JOINT APPLICATION OF LOUISVILLE GAS)
AND ELECTRIC COMPANY AND KENTUCKY)
UTILITIES COMPANY FOR CERTIFICATES)
OF PUBLIC CONVENIENCE AND NECESSITY)
FOR THE CONSTRUCTION OF A COMBINED) CASE NO. 2014-00002
CYCLE COMBUSTION TURBINE AT THE)
GREEN RIVER GENERATING STATION AND)
A SOLAR PHOTOVOLTAIC FACILITY AT THE)
E.W. BROWN GENERATING STATION)

RESPONSE OF
LOUISVILLE GAS AND ELECTRIC COMPANY
AND KENTUCKY UTILITIES COMPANY
TO THE ATTORNEY GENERAL'S THIRD DATA REQUESTS
DATED SEPTEMBER 5, 2014

Annual Distribution of Hourly Energy Production for the Brown Solar Facility

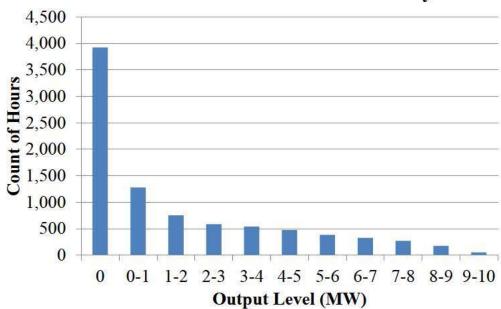
- Q-6. Provide the estimated annual average cost of energy produced by the Brown Solar Facility along with the estimated cost of energy avoided by the project for each year of the base case analysis of the facility expressed on a dollars per MWh basis, including each component of the avoided energy cost.

- A-6. See attached. The information requested is confidential and proprietary, and is being provided under seal pursuant to a Joint Petition for Confidential Protection. In the attachment, the annual production cost savings (per MWh) were computed by dividing the difference in production costs between cases C58A and C50A by annual solar generation. The present value of revenue requirements for these cases is presented in Table 36 in Exhibit DSS-1 at page 45. The production cost savings can vary somewhat from year to year since relatively small changes in generation supply and load can create challenges for the model's dispatch optimization logic. However, the overall results are reasonable considering the complete analysis period.

To further understand the avoided production costs without the model's optimization limitations, the attachment also contains the avoided energy cost from the twelve scenarios evaluated for case C50A. The avoided energy cost reflects the weighted average of the hourly marginal energy cost during the hours that the Brown Solar facility produces electricity (a histogram of forecasted generation from the Brown Solar facility is included below; the avoided energy cost values are weighted based on the Brown Solar facility's generation). These values indicate a consistent year-to-year pattern of avoided costs. Based on the first full year of avoided costs in 2017, these values are consistent with the \$40/MWh cases shown in Exhibit DSS-3. Furthermore, the compound annual growth rate of the avoided energy cost over all the cases ranges from 3% to 7% which are greater than the 2% annual growth rate assumed in Exhibit DSS-3 for the avoided energy cost.

Attachment #1 to Response to AG-3 Question No. 10 Page 11 of 11 Voyles

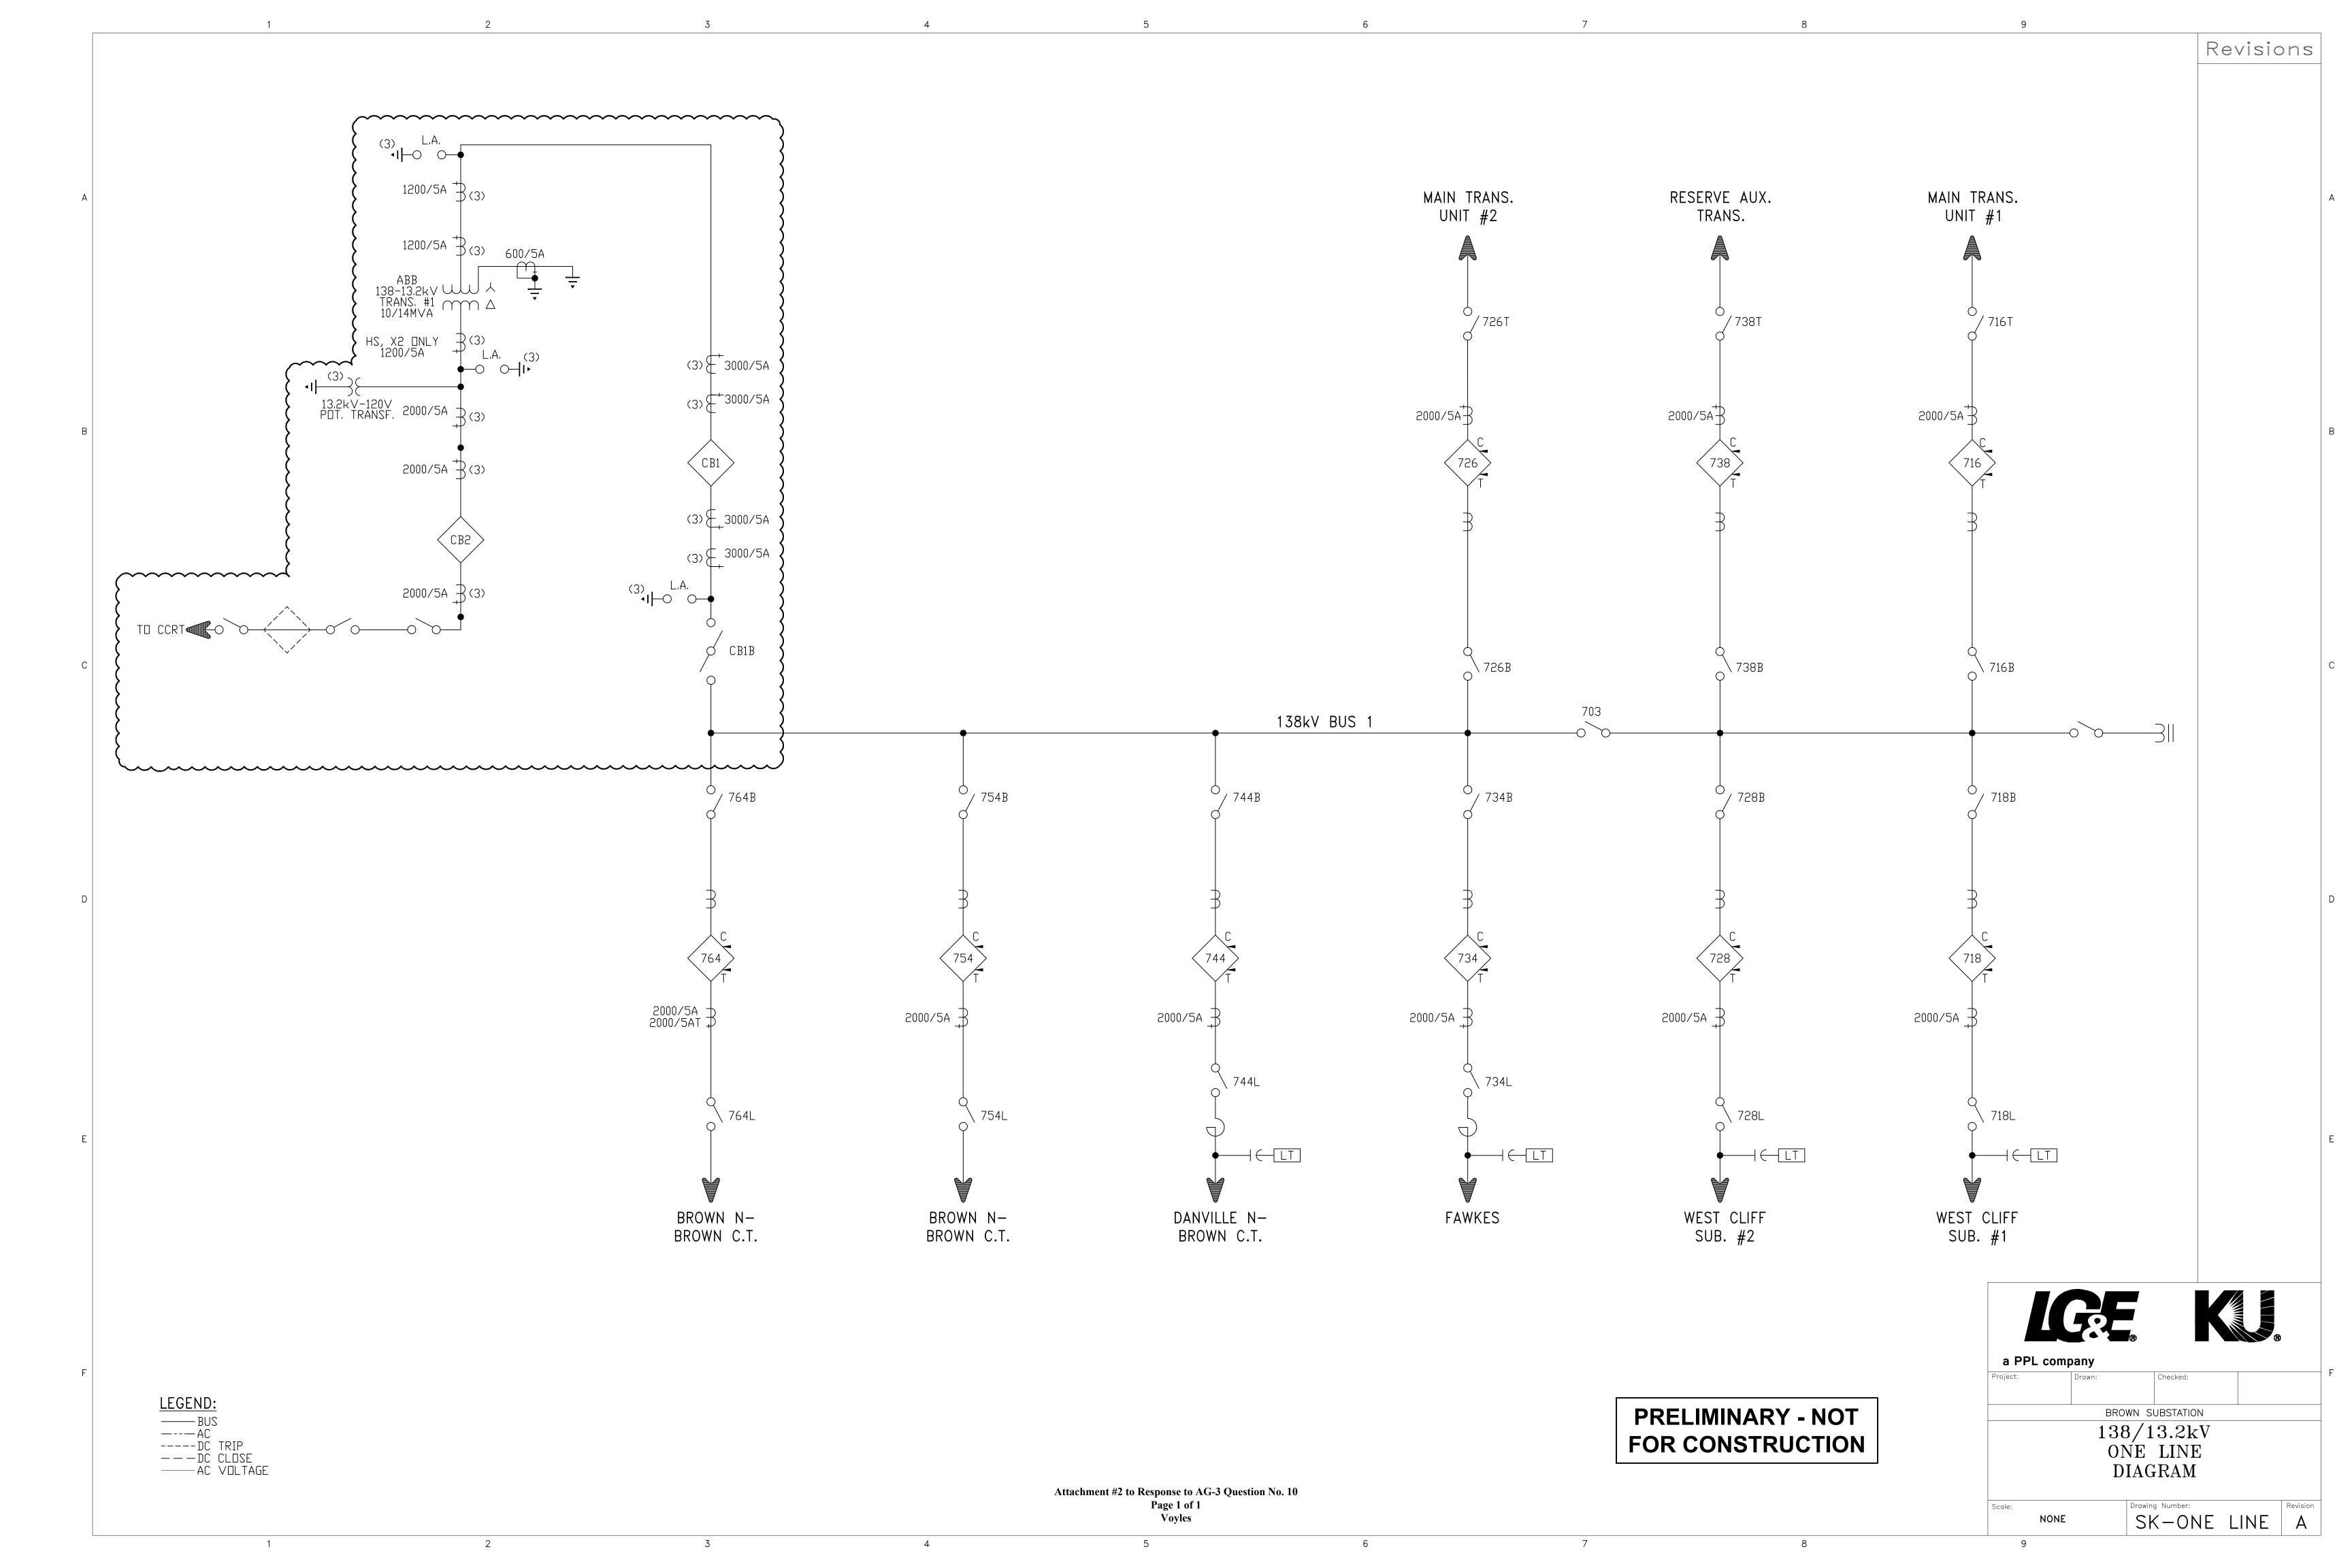
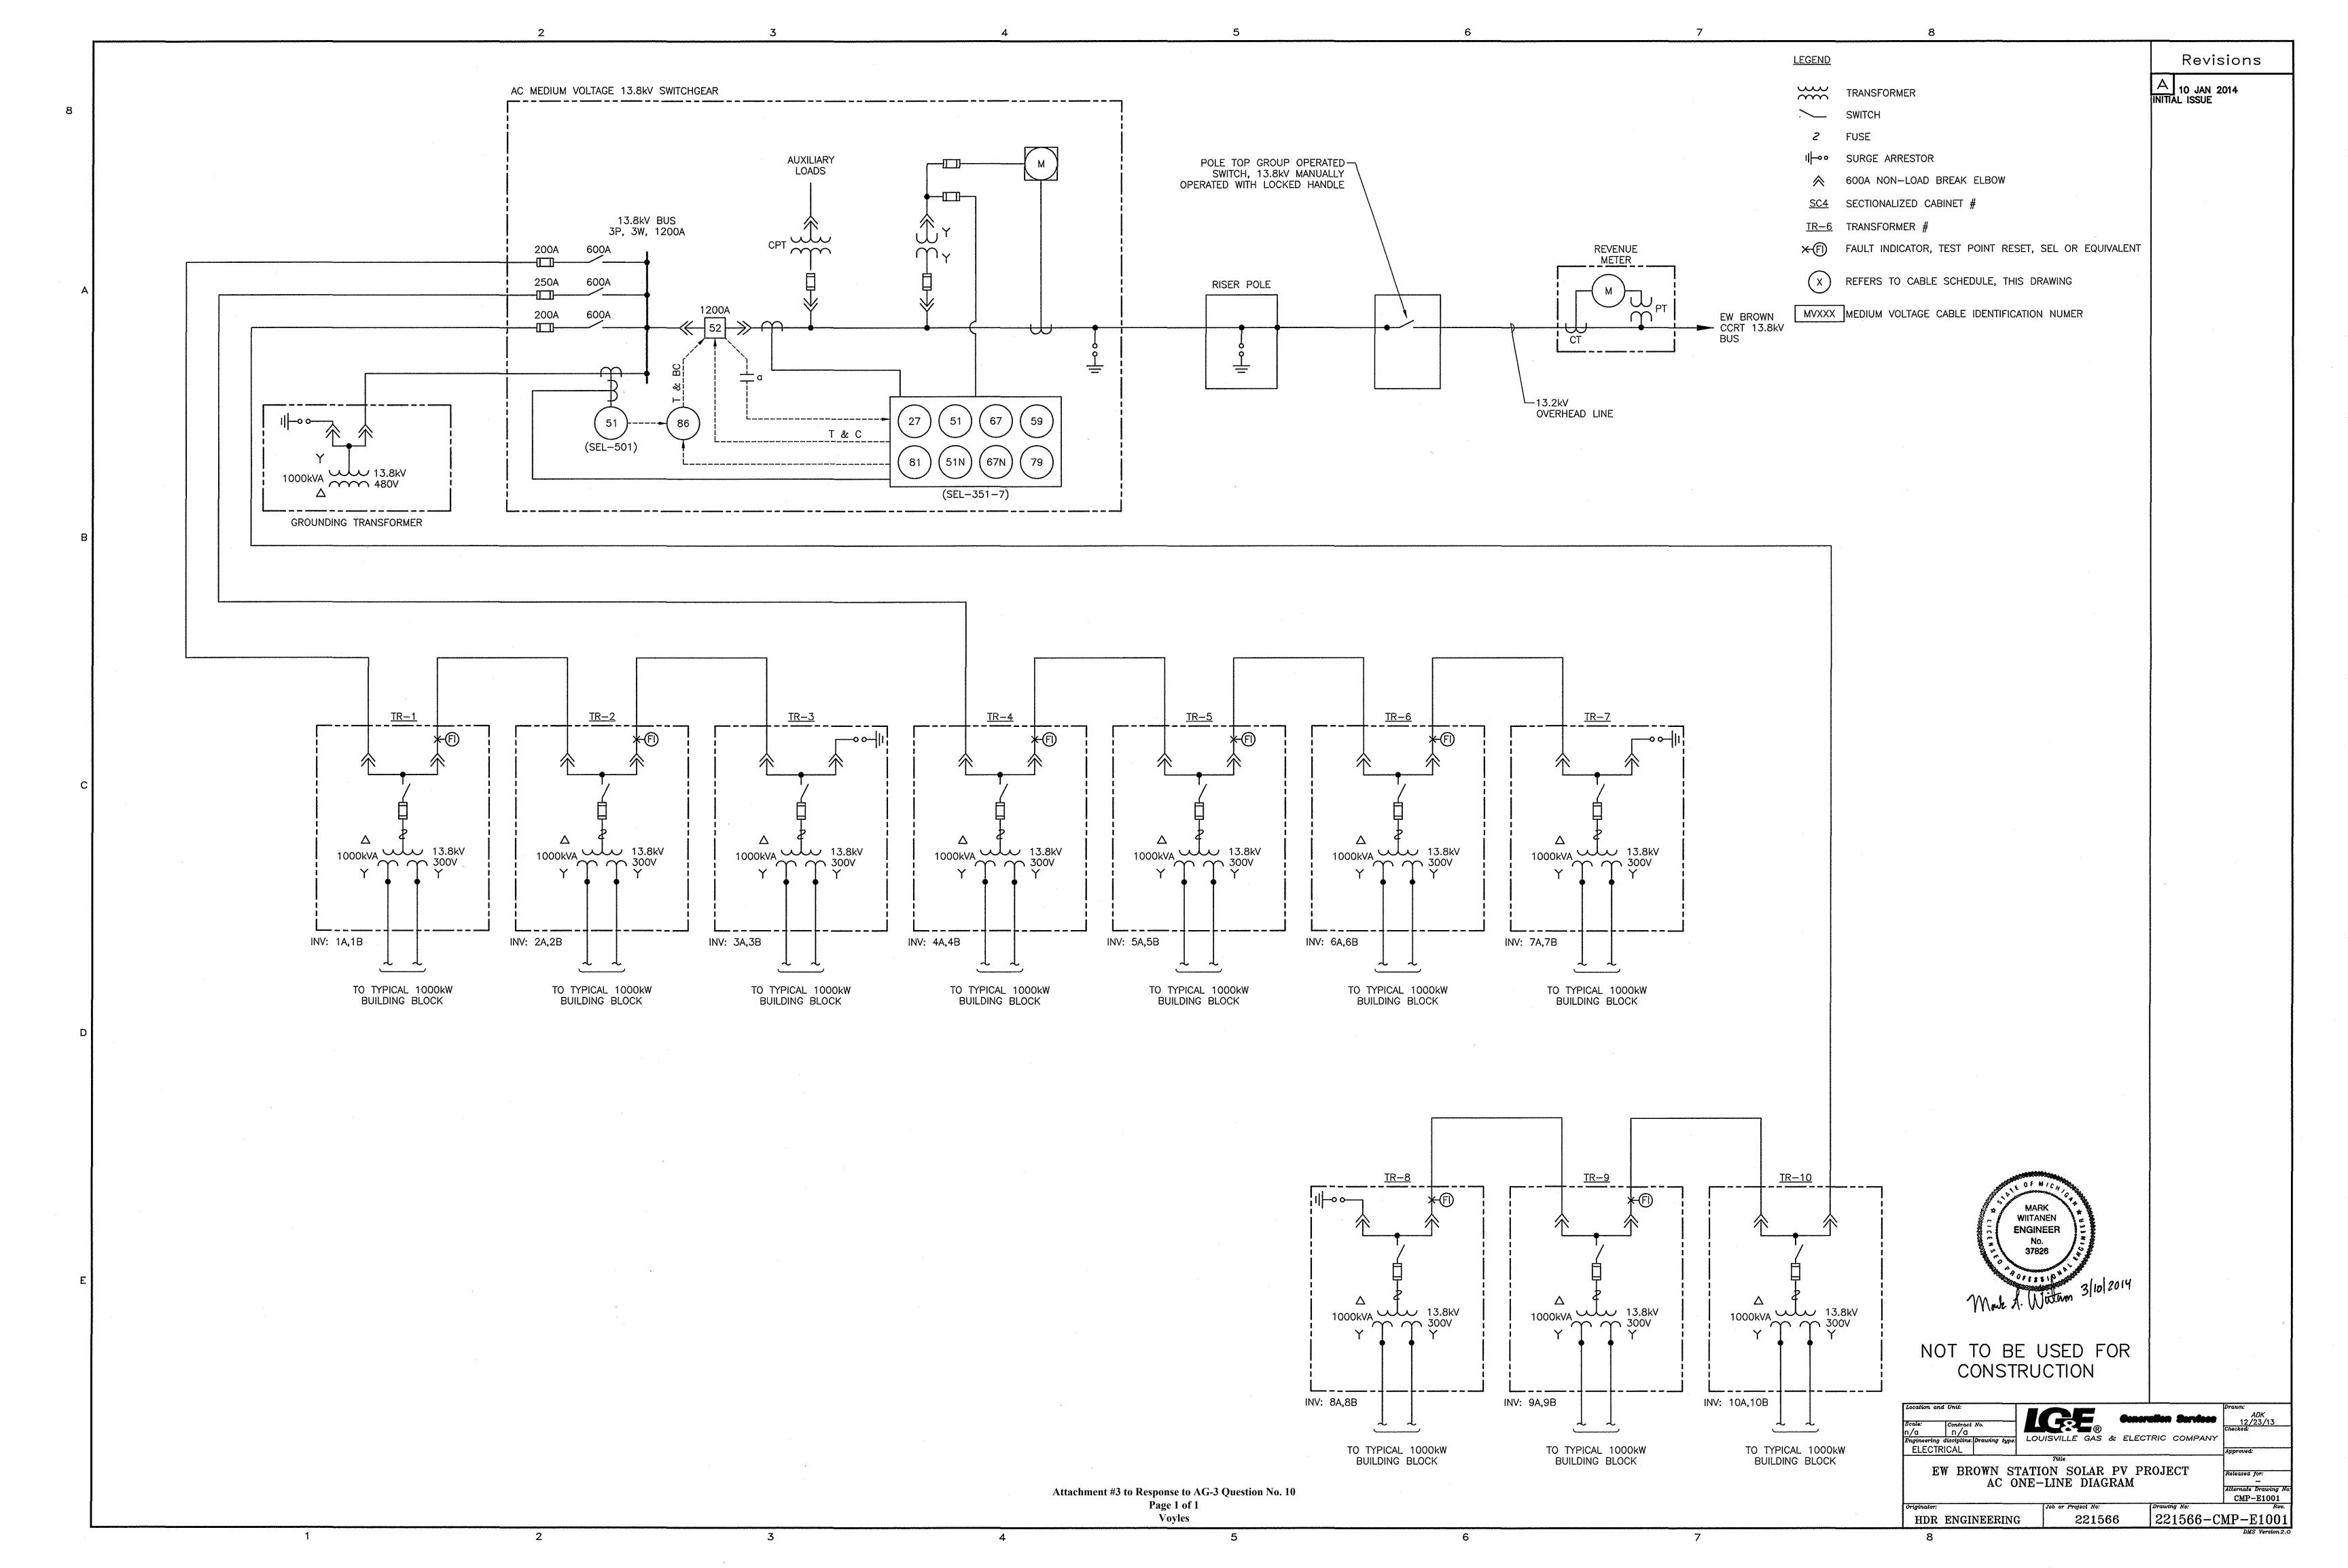
- Q-10. Reference the response to question no. 163 of the Attorney General's initial data requests. Provide the interconnection request filed for the Brown Solar Facility and discuss the results of the analysis of transmission upgrades and the related costs of such upgrades required for the Brown Solar Facility.
- A-10. Attached is the Small Generator Interconnection Request for the Brown Solar project which was submitted to the ITO (TranServ) under the Companies Open Access Transmission Tariff (OATT) on August 22, 2014.

TranServ has not started the study but no significant transmission upgrades are expected. Previously, we expected to file this request in the 2nd quarter, however, the Companies decided to hold the request until after the informal conference with the Commission Staff and Intervenors. This request is next in the queue for TranServ and the Companies would anticipate a starting date for the study later this year. Also see responses to AG 1-91 and AG 2-60.
